DEVELOPMENT REVIEW BOARD REPORT

Fervor Creative Renovation and Addition 52-DR-2016

Request: Request approval of the site plan, landscape plan, and building elevations for renovations and an addition to an existing two-story office building, with 4,458 square feet of building area, on a 0.2-acre site.

BUILDING ELEVATIONS

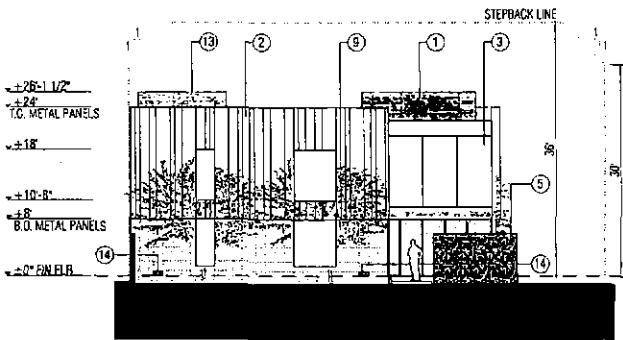
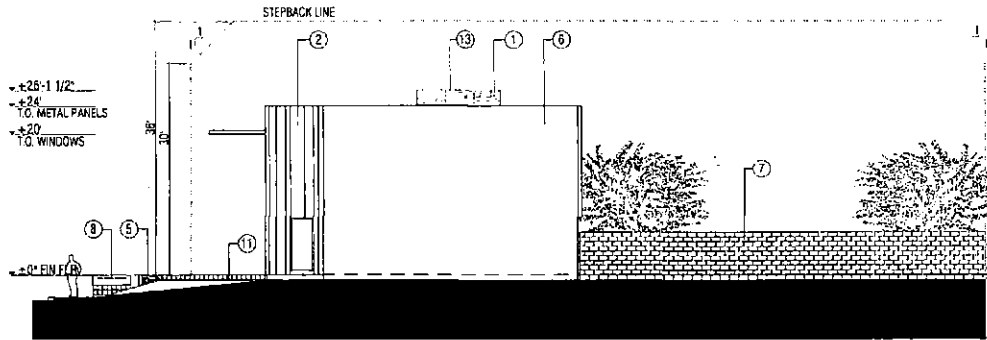
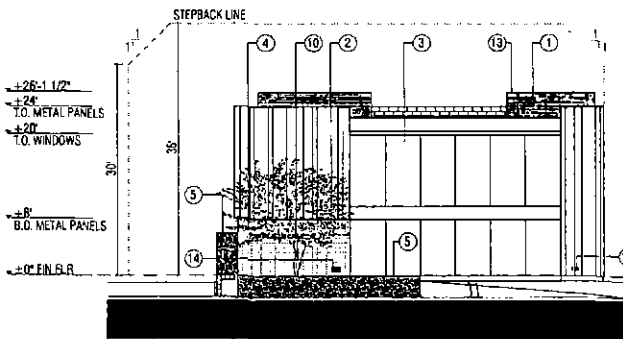
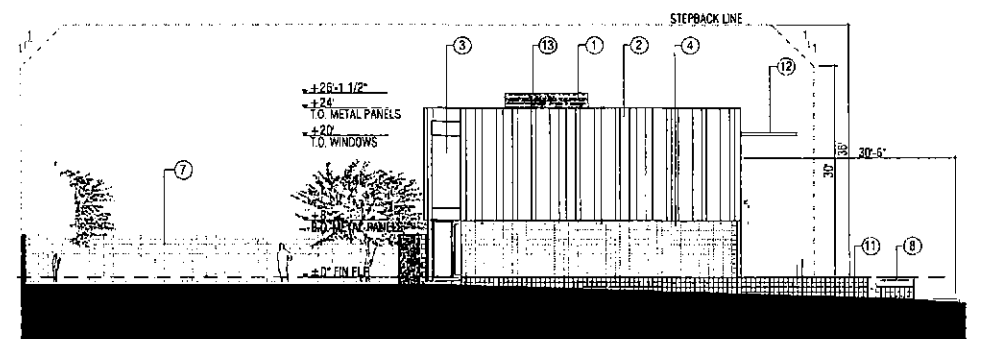
The window system is proposed in a custom twelve-inch-deep steel frame, designed to have the glass set flush with the outside edge of the steel. Without the window glazing recessed a minimum of fifty (50) percent of the wall depth, staff has concerns with the proposed design as it pertains to conformance with the Design Standards and Policy Manual, Scottsdale Sensitive Design Principles, Downtown Urban Design and Architectural Guidelines, and the Design Guidelines for Office Development.

- ~~2. All exterior window glazing shall be recessed a minimum of fifty (50) percent of the wall depth, including glass windows within any tower/clerestory elements. The amount of recess shall be measured from the face of the exterior wall to the face of the glazing, exclusive of external detailing. With the final plan submittal the developer shall provide head, jamb, and sill details clearly showing the amount of recess for all window types. Stipulation deleted per DRB approval~~
3. All exterior doors shall be recessed a minimum of thirty (30) percent of the wall depth, the amount of recess shall be measured from the face of the exterior wall to the face of the glazing, exclusive of external detailing. With the final plan submittal the developer shall provide head, jamb and sill details clearly showing the amount of recess for all door types.
